PRODUCT CHANGE NOTICE

PCN/EOL#16-036

ZN4PD1-50-S+

Discontinuation of ZN4PD1-50-S+ and replacement by ZN4PD1-63HP-S+

ORIGINAL PART: ZN4PD1-50-S+

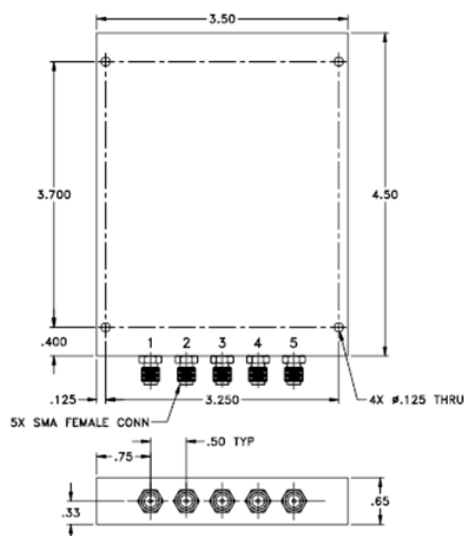
Case Style Change from

UU846 to UU846-4

In new outline UU846-4, connectors at location 1 and 2 are moved on the left side by .250" (6.35mm) and connectors 4 and 5 are moved on the right side by .250" (6.35 mm)

REPLACEMENT PART: ZN4PD1-63HP-S+

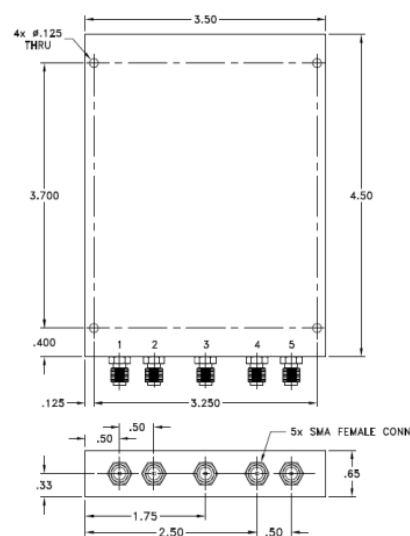
Internally, PCB material is changed from OAK to TLP.

PERFORMANCE COMPARISON CURVES (TYPICAL)

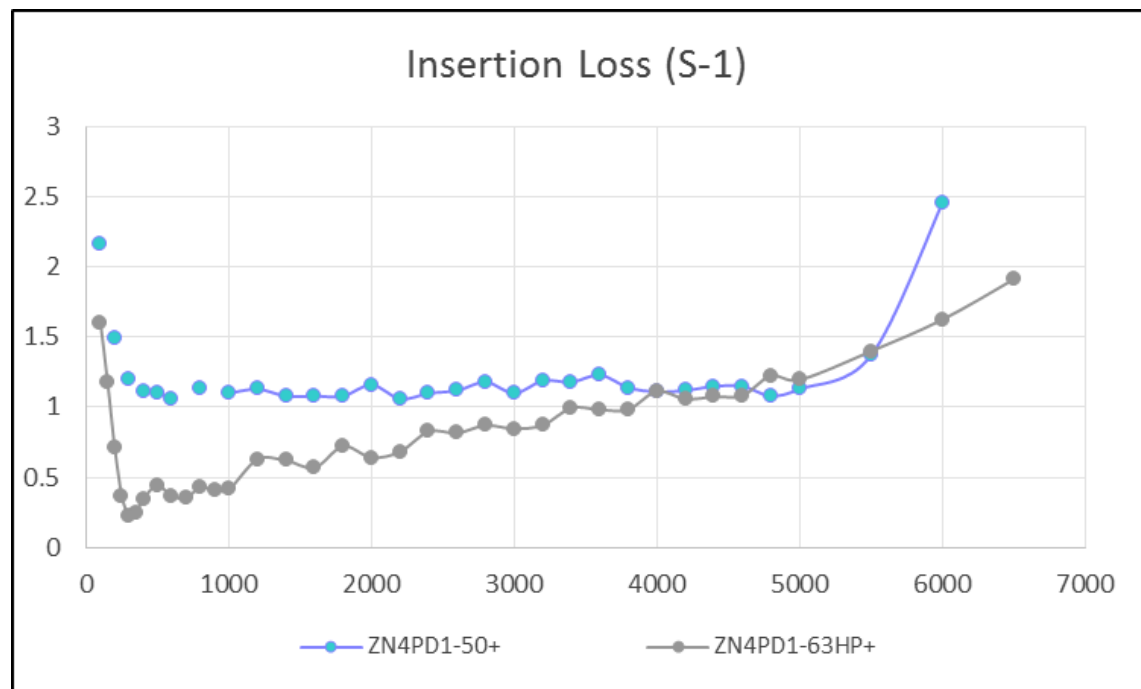
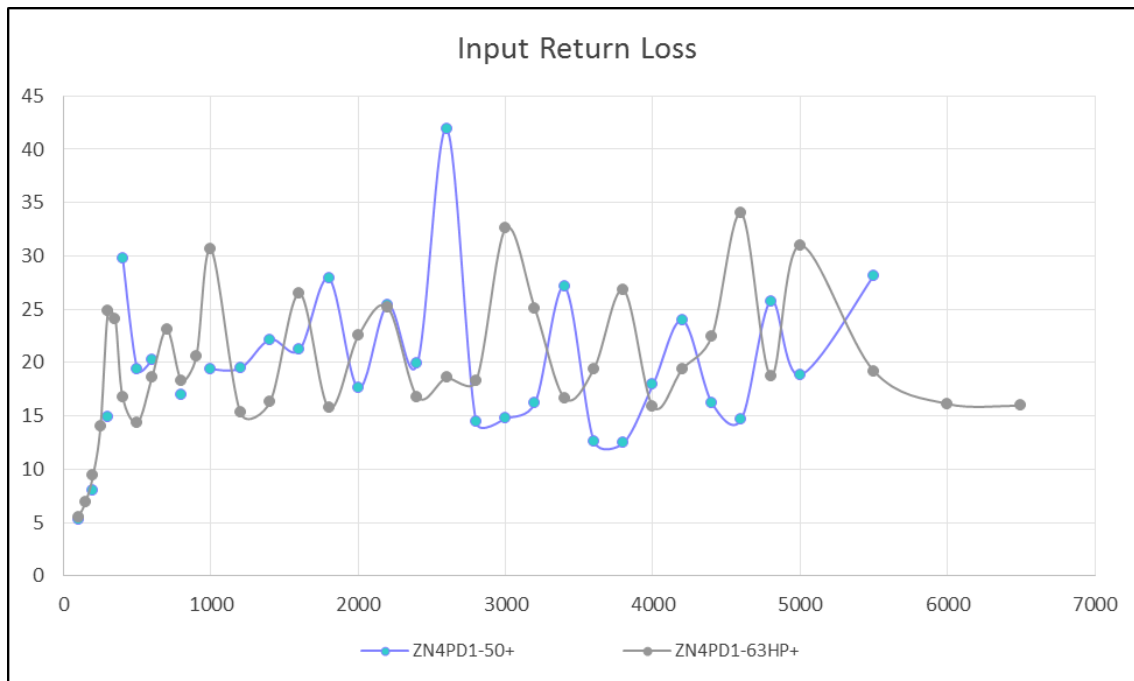
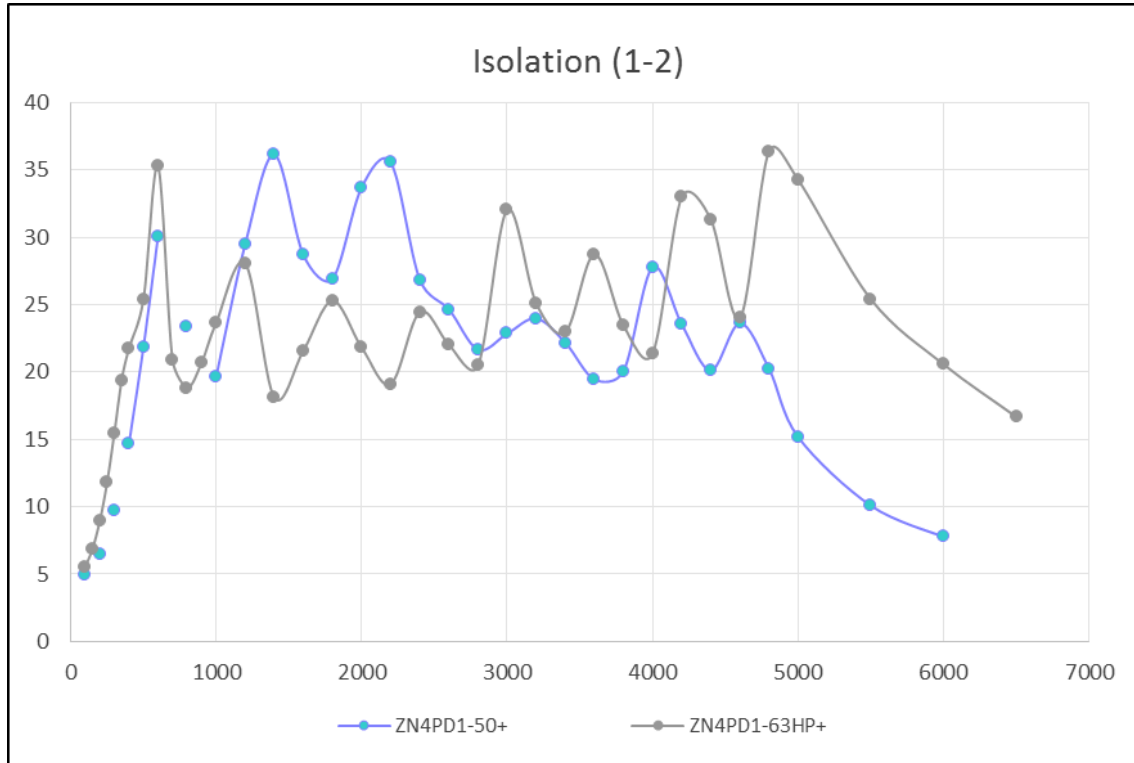
Following is a summary of changes/improvements. Typical performance curves are given below
